# Service Bulletin

BKSB-1010A  
Issue Date 1-4-02

**Issue:** Insufficient audio output of GPH.

**Affected Models:** All Pre-Flash BK Radio G-Series portables.

Figure 1

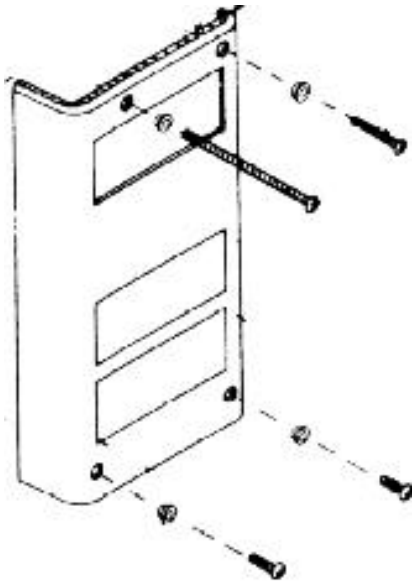
1. Turn off radio and remove battery.
2. Disassemble radio.
  - a) Remove 4 screws from rear cover of radio. (Fig. 1)
  - b) Pull front radio assembly straight out.
  - c) Check marking on speaker. (JEMA speakers will be marked "JNR-04506N-A1521". If the speaker has this marking modification is not necessary.)
  - d) Remove the five screws holding in the Options board and gently disconnect from keyboard. (Fig. 2)
  - e) Remove screws holding white speaker clip and remove speaker. (Fig. 3)
  - f) Unsolder the wires connected to the speaker.
  - g) Install and solder new speaker. (P/N 1301-20034-702) NOTE: Be sure to re-insulate the connection.)
  - h) Reinstall speaker clip and Options Board.

Figure 4

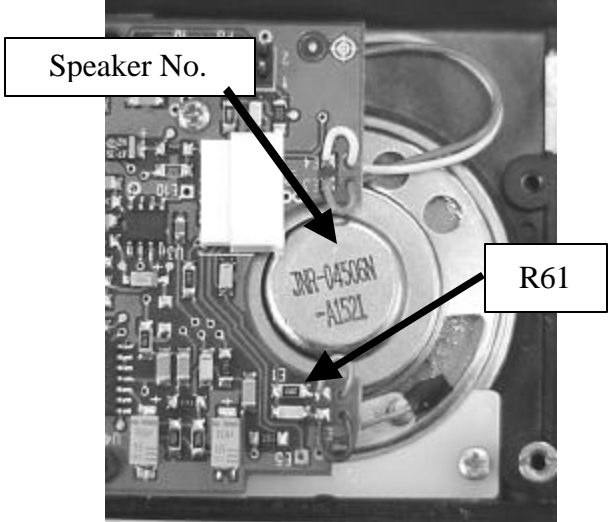
1. Verify value of R61. (Fig. 4)
2. If R61 value is 000 continue to the next step.
3. If R61 value is 2.2 Ohm, replace with 0 Ohm resistor (P/N 4718-50317-140).

Figure 5

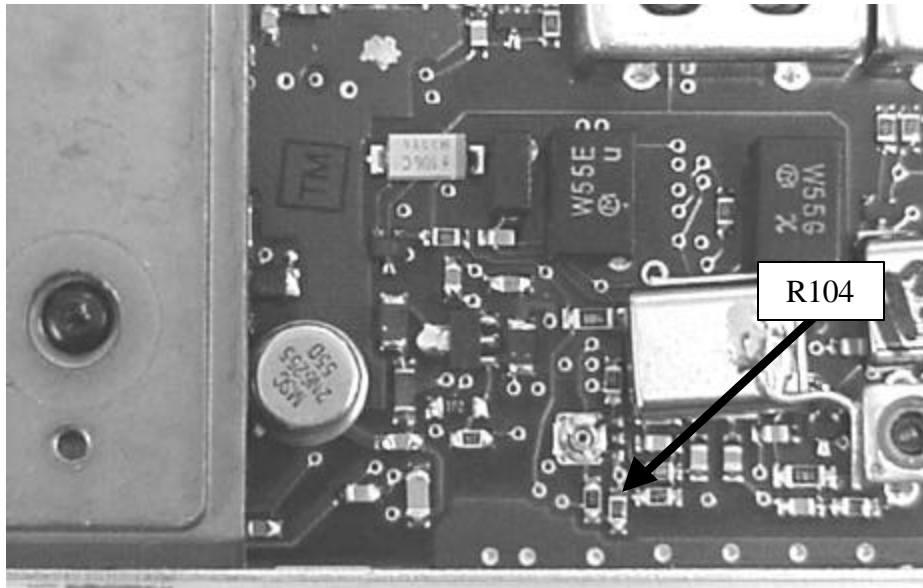
1. Verify value of Revision of Rx/Tx board. (Fig. 5)  
(This step is only valid for 602-765 Rev. C circuit boards.)
2. If R104 value is 3.3K Ohm continue to the next step.
3. If R104 value is 1.8K Ohm, replace with 3.3K Ohm resistor (P/N 4724-00332-233).

**NOTE: If R104 is not present where shown this step cannot be performed.**
